Access Compliance Report Public Rights-of-Way (Curb Ramps)

Intersection ID: 19746 Main Street: PINEBURR_RD Cross Street: THERMAL_RD Location: S

ADA ID: 7097A2CC38AE Ramp Type: PerpDiag Initial Pass/Fail: Fail Overall Compliance: No Severity Score: 33.75

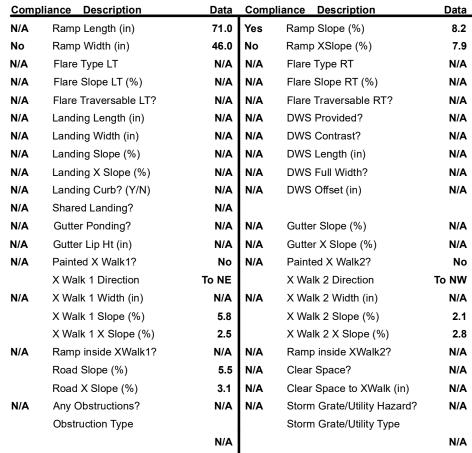
R304.5.1, R304.5.3

Remove & Replace Curb Ramp With
Two New Directional Ramps or
Equivalent.
